Access Compliance Report

Public Rights-of-Way

Intersection ID: 46748	Main Street: SUPERIOR_ST	Cross Street: NORMANS_LANDING_DR	Location: N
ADA ID: 3AC8207E0BBB	Ramp Type: Perp	Initial Pass/Fail: Fail	Overall Compliance: No
Severity Score: 1.25			
Codes/Mitigation Info/Possible Solution		Field Measurements/Component Compliance

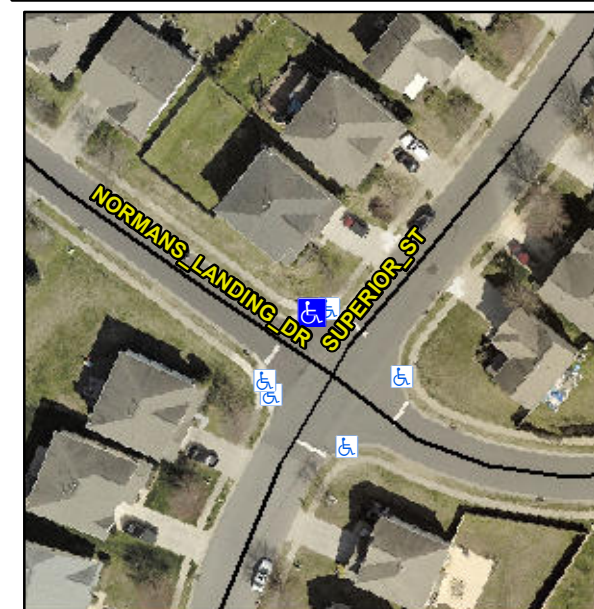
Not Found, R304.5.3

Compliance	Description	Data	Compliance	Description	Data
N/A	Ramp Length (in)	48.0	Yes	Ramp Slope (%)	6.4
Yes	Ramp Width (in)	60.0	No	Ramp XSlope (%)	4.4
N/A	Flare Type LT	N/A	N/A	Flare Type RT	N/A
N/A	Flare Slope LT (%)	N/A	N/A	Flare Slope RT (%)	N/A
N/A	Flare Traversable LT?	N/A	N/A	Flare Traversable RT?	N/A
N/A	Landing Length (in)	N/A	N/A	DWS Provided?	N/A
N/A	Landing Width (in)	N/A	N/A	DWS Contrast?	N/A
N/A	Landing Slope (%)	N/A	N/A	DWS Length (in)	N/A
N/A	Landing X Slope (%)	N/A	N/A	DWS Full Width?	N/A
N/A	Landing Curb? (Y/N)	N/A	N/A	DWS Offset (in)	N/A
N/A	Shared Landing?	N/A			
N/A	Gutter Ponding?	N/A	N/A	Gutter Slope (%)	N/A
N/A	Gutter Lip Ht (in)	N/A	N/A	Gutter X Slope (%)	N/A
N/A	Painted X Walk1?	No	N/A	Painted X Walk2?	N/A
	X Walk 1 Direction	To SW		X Walk 2 Direction	N/A
N/A	X Walk 1 Width (in)	N/A	N/A	X Walk 2 Width (in)	N/A
	X Walk 1 Slope (%)	0.7		X Walk 2 Slope (%)	N/A
	X Walk 1 X Slope (%)	2.0		X Walk 2 X Slope (%)	N/A

Remove & Replace Entire Ramp.
